Staff Report to the Zoning Administrator

Application Number: 181024

Applicant: Matson Britton Architects
Owner: Jim and Sue Vaudagna
APN: 043-095-14
Site Address: 379 Beach Drive, Aptos

Project Description: The proposed project includes demolition of an existing three-story single-family dwelling and construction of a new three-story replacement single-family dwelling. The project includes excavation of the toe of the coastal bluff, construction of several coastal bluff stabilization features including two retaining walls (9 and 11-feet high respectively) in the rear yard, as well as a 10-foot high geobrug debris flow fence located 30-40 feet upslope from the proposed home. Requires a Coastal Development Permit and Variance approval to reduce the minimum 20 foot front yard setback to 10 feet, to increase the maximum height of 28 feet to 32.5 feet, to increase the maximum number of stories from two to three and to increase the allowed 50% floor area ratio to approximately 60%.

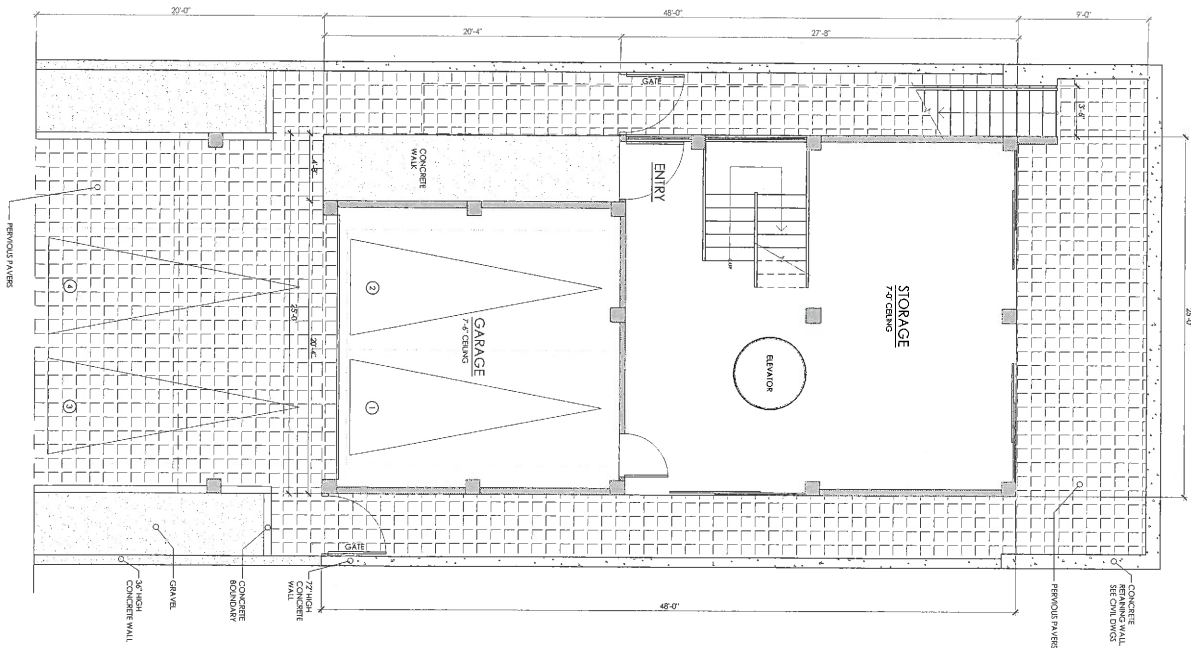
Once the design slide debris mass volume has been determined based on quantitative analyses, the project geologist should revise the project Geologic Cross Section using the current house design (Sheet P3 – MBA 10/11/17) and illustrating the post event configuration of the slide mass debris.

6. Sheet P3 shows fill in front of the upper retaining wall, whereas sheet C2 shows an open-faced retaining wall. Please clarify.

Revised:
Plate 2

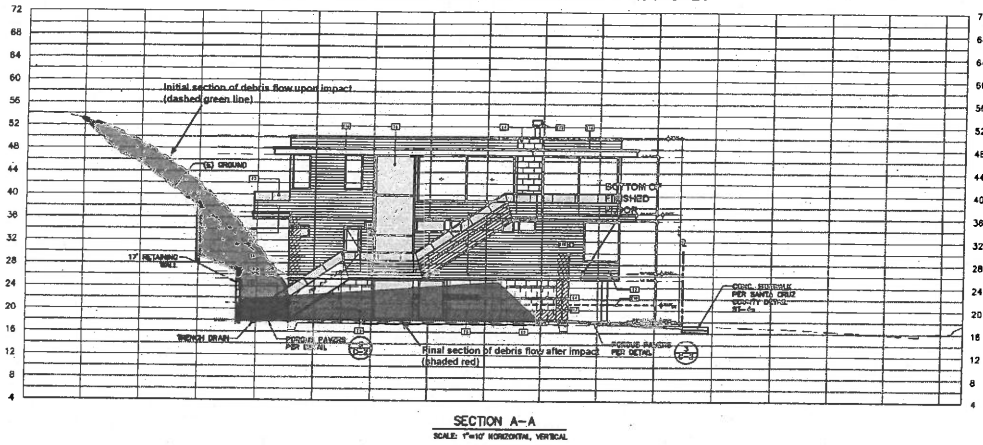
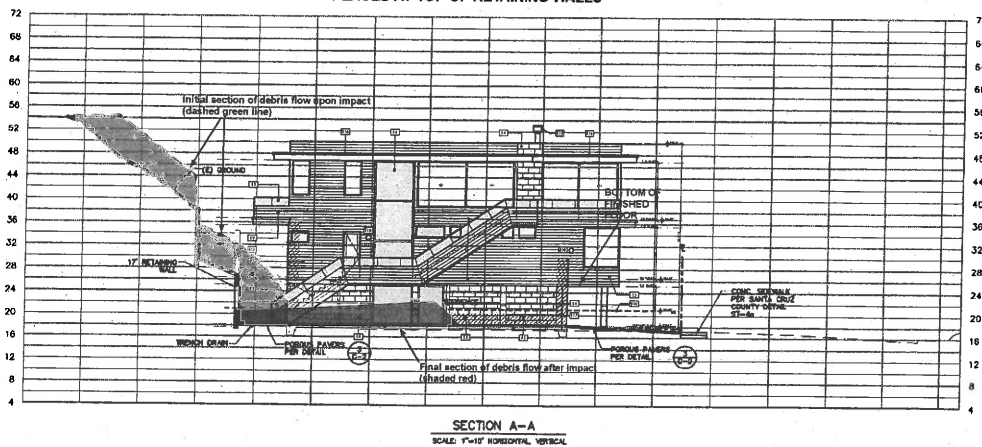
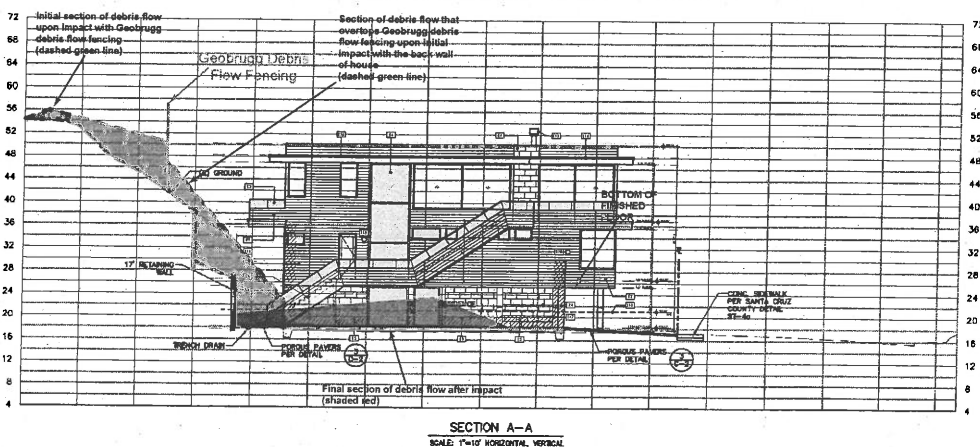
County Comment 2. The project geologist has qualitatively determined anticipated modes of slope failure above 379 Beach Drive as well as estimated debris impact velocities. After the quantitative slope analyses are complete, the project geologist and geotechnical engineer should work together to determine a project design slide debris mass volume. Once the design slide debris mass volume has been determined based on quantitative analyses, the project geologist should revise the project Geologic Cross Section using the current house design (Sheet P3 -MBA 10/11 /17) and illustrating the post event configuration of the slide mass debris.

Zinn Geology Response To County Comment #2 - We have since worked with Project Geotechnical Engineer of Record, Pacific Crest Engineering, and given them geological input for their quantitative analysis. This was an iterative process that also involved some fundamental changes to the civil engineering of slope and retaining wall behind the house. The debris flow parameters issued by Pacific Crest Engineering can be seen on the attached Plate 2.

We have plotted the configuration of the quantitatively derived design debris flow on a cross section that represents the modified proposed civil engineering configuration of the back slope and retaining walls, as well as the most recent version of the house from the Matson-Britton Architect plans (see Plate 2). We have plotted three different mitigation scenarios on that base section and depicted our interpretation of the design debris flow cross section at the moment of impact and the configuration of the debris flow after it comes to rest (Plate 2).
